SERVICE No. 196 BULLETIN

Piper Aircraft Corporation

SUBJECT: Rudder Tab Horn Bolt Installation

MODEL AFFECTED: PA-23-250 Aztecs, Serials 27-7 to 27-107 inclusive, 27-109 to 27-133 inclusive, 27-135 to 27-281 inclusive, 27-284, 27-293, 27-297, 27-301 to 27-303 inclusive, 27-305 to 27-310 inclusive, 27-312, 27-313, 27-315 and 27-317.

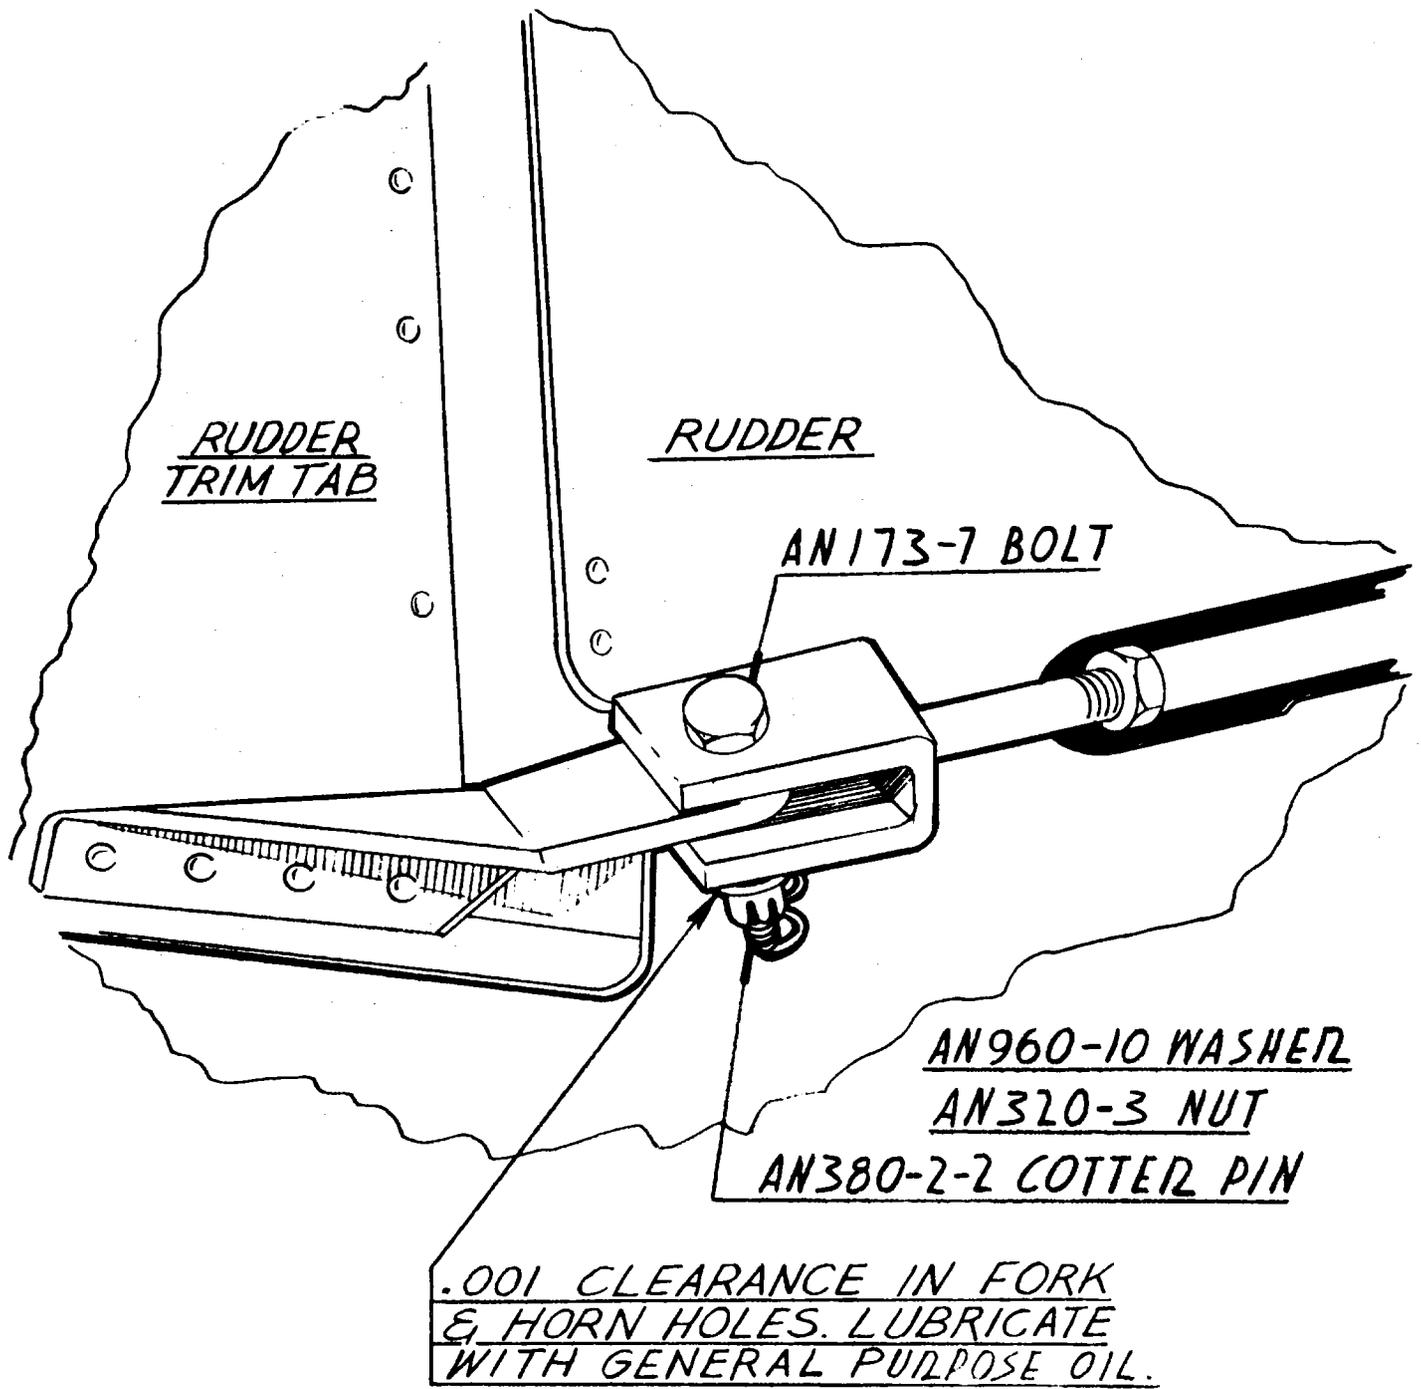
This Bulletin is to advise that there is a possibility the AN173-7 close tolerance bolt used to connect the rudder trim tab rod to the rudder trim tab may bind and restrict the movement of the rudder trim tab.

It is requested that this bolt be removed, discarded and replaced with a new AN173-7 close tolerance bolt. The new bolt shall be installed with .001 clearance in the holes in the fork, part number 16514-00, and horn assembly, part number 16108-00.

BOLT SHOULD BE FREE TO ROTATE BY HAND
